A NEW MEDICAL MARIJUANA DISPENSARY INTERIOR TENANT FINISH FOR:

GRD KIRKSVILLE, LLC
201 SE MO-291
LEE'S SUMMIT, MISSOURI 64063

- G-000 COVER SHEET
G-001 STATE AND LOCAL REGULATIONS
G-002 BUILDING CODE SUMMARY
G-003 RESPONSIBILITY MATRIX
- A-100 FLOOR PLAN & DETAILS
A-200 INTERIOR WALL SECTIONS
A-300 SCHEDULES
A-400 CEILING FRAMING, REFLECTED CEILING PLAN

RESPONSE TO PLAN REVIEW COMMENTS (5/23/2022)

FLOOR PLAN,
INT.
ELEVATIONS

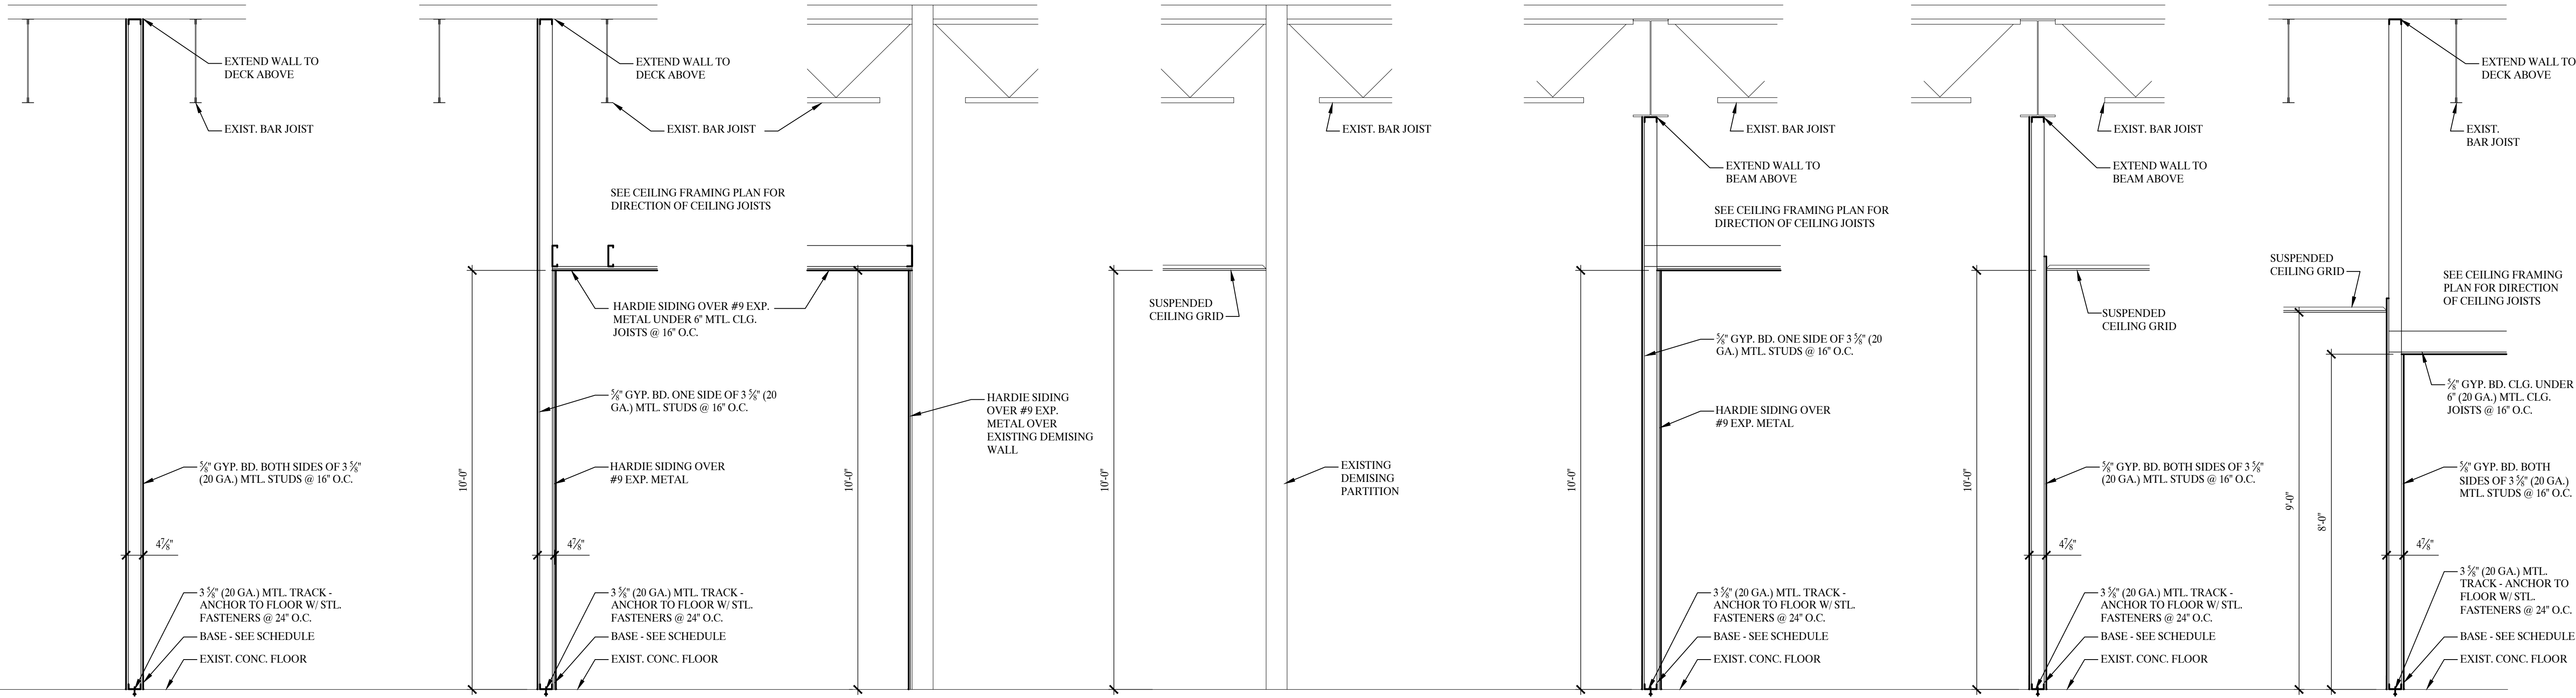
- PATIENT TOILET 104 IS MODIFIED TO PROVIDE THE MINIMUM 18" CLEARANCE AT LATCH SIDE OF DOOR.
- A BOTTLED WATER APPLIANCE SHALL BE PROVIDED.
- EPOXY BASED PAINT SHALL BE USED AS WALL FINISHES WITHIN TOILET ROOMS AND MOP SINK AREA, AS REQUIRED.
